Director's Report

Project Name: Edendale

Description: Final Site Plan Approval

RE: Edendale Crossing
Final Site Plan Submission

Cedar Island & White Lake Middle School Sidewalk Plan
"EDENDALE CROSSING" SITE CONDOMINIUM
PART OF THE SOUTHEAST 1/4 OF SECTION 29, T3N, R8E
WHITE LAKE TOWNSHIP, OAKLAND COUNTY, MICHIGAN

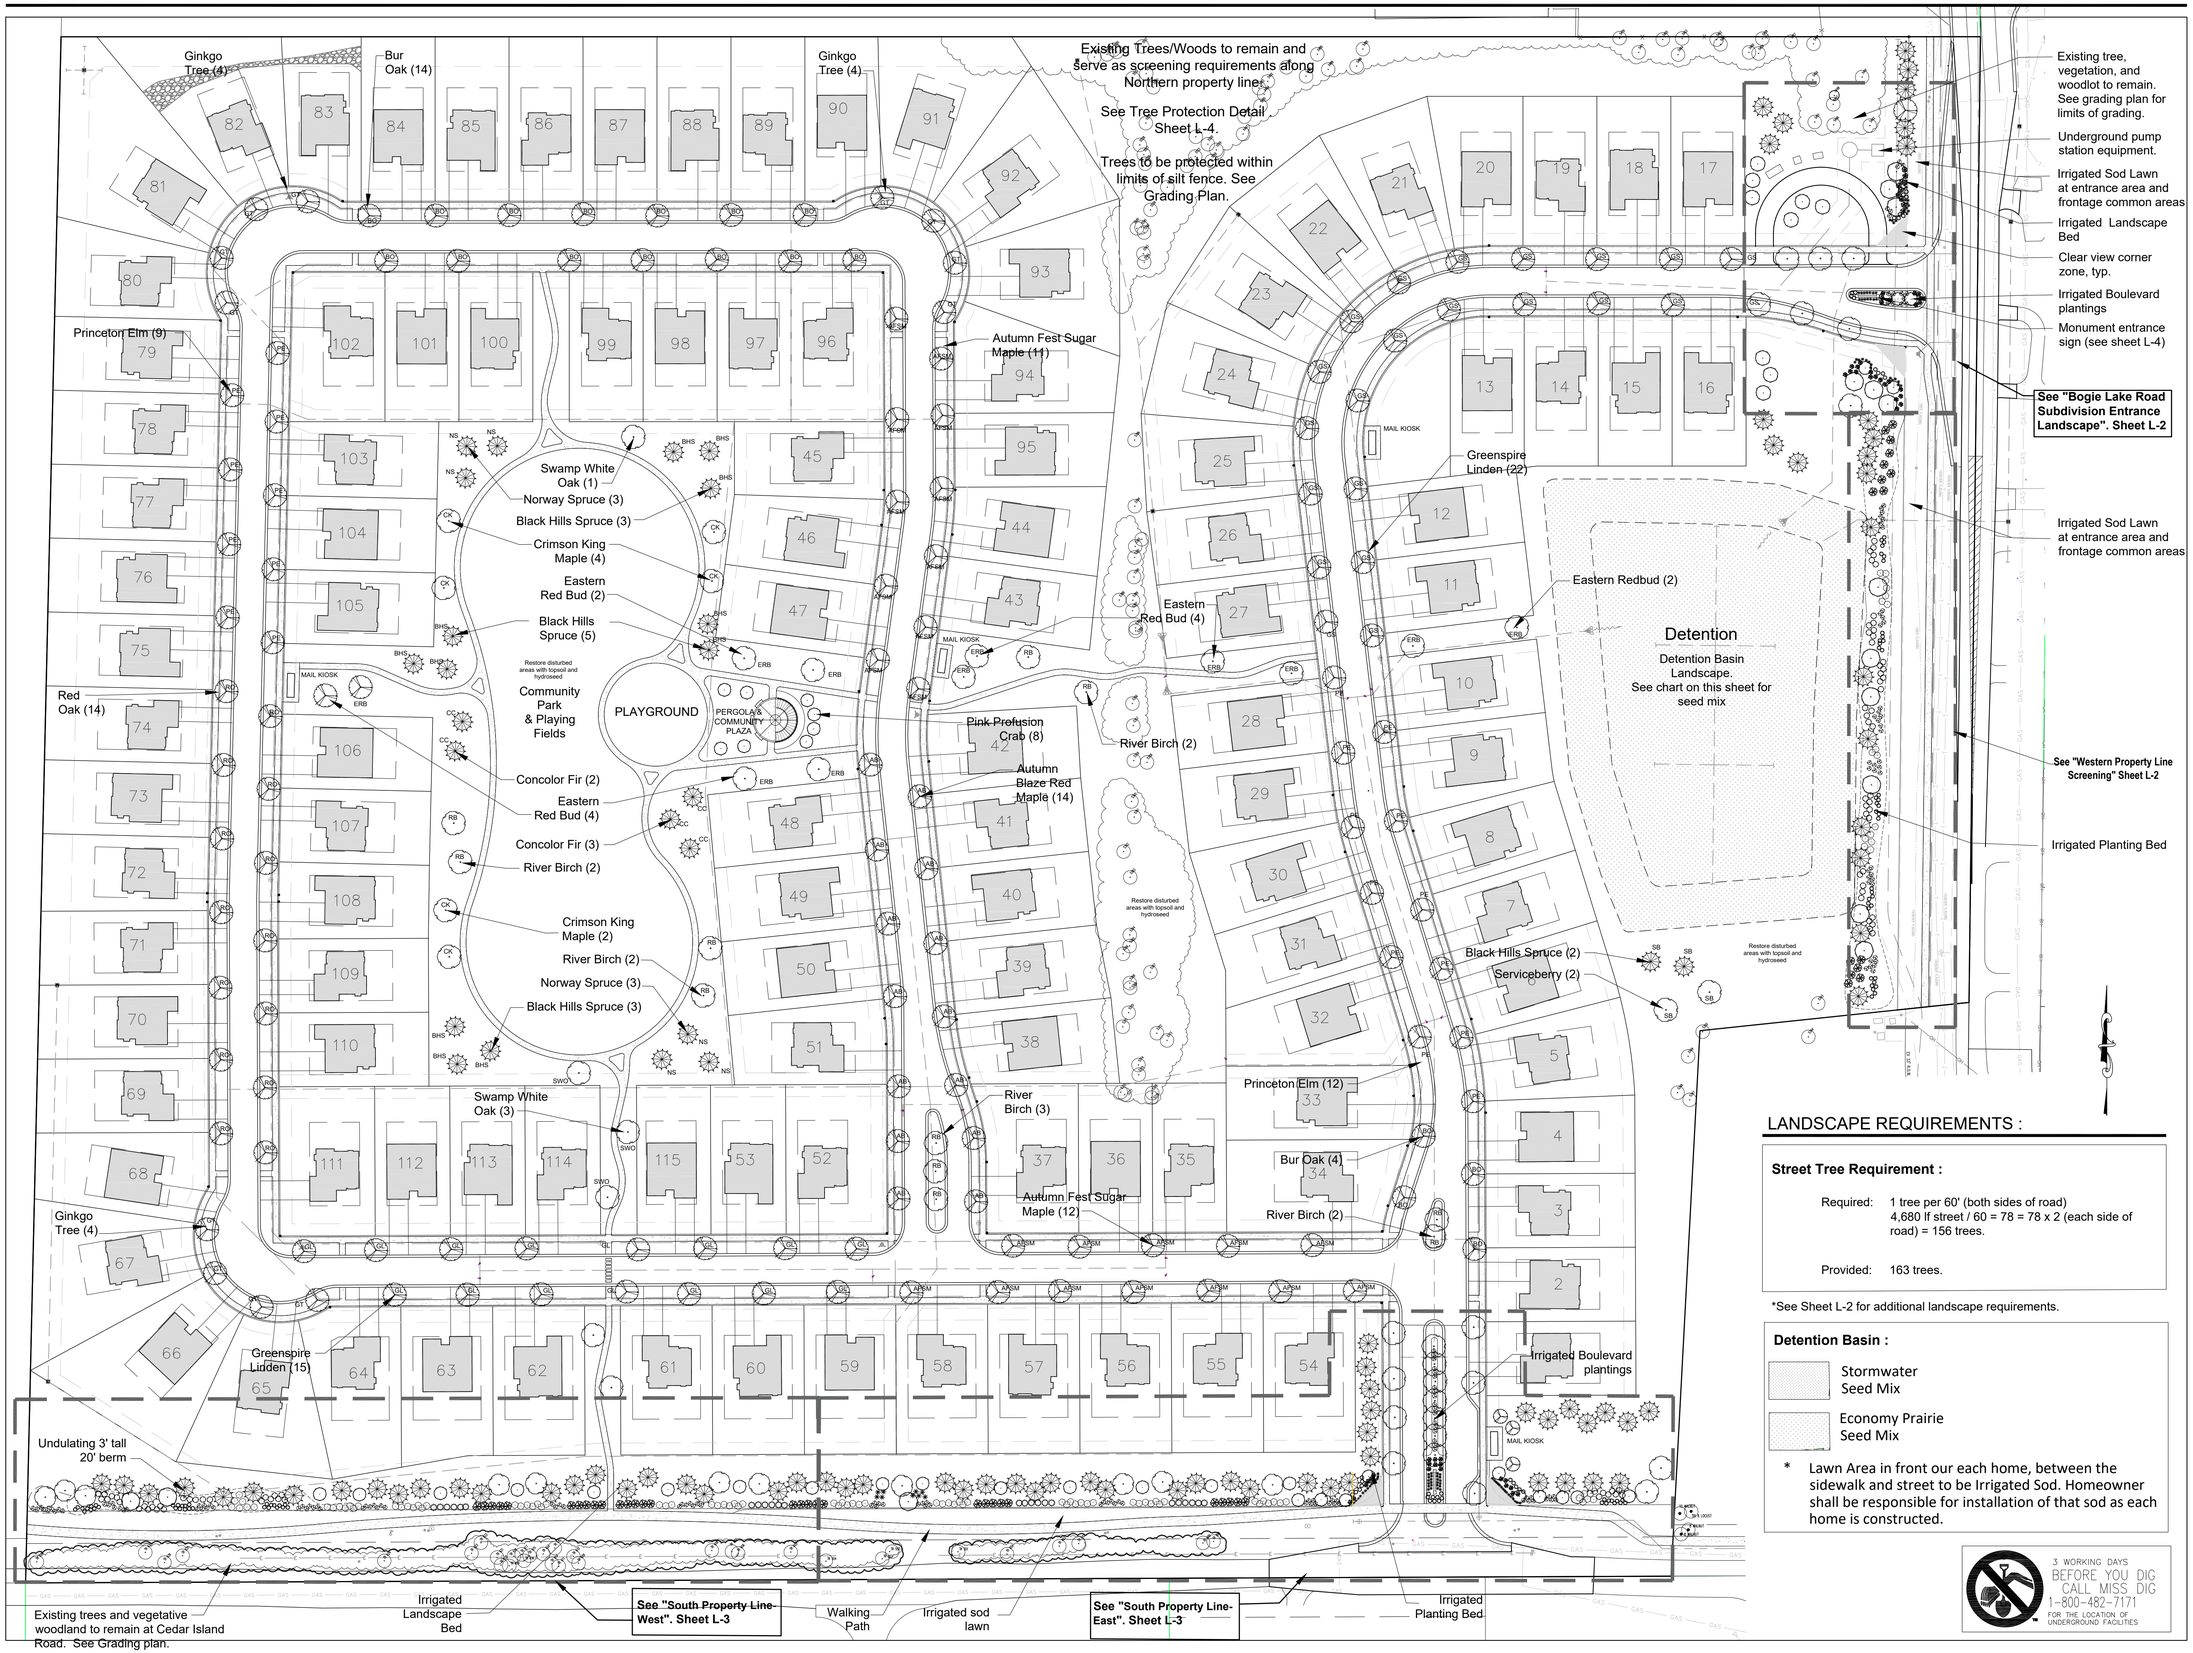
1. *Sheet 19-Cedar Island & White Lake Middle School Sidewalk Plan- Remove 'Proposed Pedestrian School Crossing' note to the west of Carla Hills Drive as this was where the safety path was previously proposed.* **Comment outstanding.**
2. *Sheet 3- The number of lots for each phase has not been updated to correspond with the reduction in total units from 125 to 120. Please update.* **Comment addressed. Quantities have been updated.**

Comment is now outstanding due to the following requested clarification and change in sidewalk layout: The proposed 8' wide path along Cedar Island Road has now been shifted in its entirety to the north side of the road. The Existing Conditions Plan- Overall (Sheet 2) shows 43' existing ROW along Cedar Island Road in front of Parcel 12-29-476-007 while the Overall Site Plan and Notes (Sheet 3) shows the existing ROW in this area as 33'. Please clarify. The right of way along Parcel -007 will determine whether a sidewalk easement will need to be granted by this property owner. Additionally, please revise '8' Wide Safety Path Connection to Huron Valley School Parking Lot' reference notes on Sheets 3 and 5 from Sheet 17 to Sheet 19. Comment addressed. ROW width has now been corrected to 43' on the 'Overall Site Plan & Notes' (Sheet 3), so it now appears that an easement for the proposed path would not be required from Parcel -007. In addition, sheet references have been updated. **Comment remains as a notation.**
